Frymaster®

Service Bulletin

Subject: Fenwal Module Replacement Kits

Models: LOV (BIGL, BIGLA, BIGLA-T), FilterQuick (FQG30, FQG30-T), OCF (FPGL), H50/52/55 Gas Fryers EXCEPT FOR FRYERS IN AUSTRALIA
01/10/2024

Fenwal 8075949 Ignition Module **Figure 1**	**McDonald's LOV (BIGL30, BIGLA30, BIGLA30 Touch) Fryers;** **Serial Numbers 1806 to Present** **FilterQuick (FQG30, FQG30 Touch) Fryers;** **Serial Numbers 1806 to Present** **OCF (FPGLx30) Fryers** **Serial Numbers 1806 to Present**

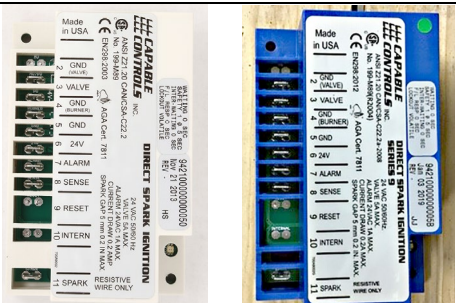
Honeywell and Capable Control ignition modules have been **discontinued.** The ignition module conversion replacement kits contain Fenwal ignition modules (see Figure 1). The Fenwal module is a single-spark module. Two modules are required for each frypot (one for each side of a split vat).

NOTE: The replacement module is 8075949 (which is a one [1] module for one [1] module replacement).

PART #	8075949

GEVEG Interface Board
Figure 5

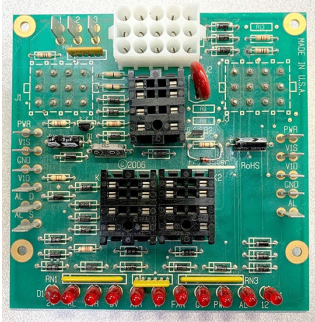
ALL H50/52/55 fryers manufactured WITH GEVIG boards AND Capable Control Modules (see Figure 5) (FMHx5x, FPHx5x, MJHx5x, PHx5x, FMPHx5x, FPPHx5x, BIPHx5x) Fryers	
ORIGINAL PART # 's	REPLACEMENT KIT PART #
8075691 8075872	8263686 See **NOTE** below.

NOTE: The replacement kit will require a kit 8263686 for **EACH** Capable Control Module replaced.

NOTE: Once the module(s) are replaced, allow the fryers to start heating up and check the microamps when calling for heat. The DC microamp output for flame proofing is 0.7μA to 2.4μA; 1.3μA to 1.8μA is a good range.
Lockout is 0.5μA.
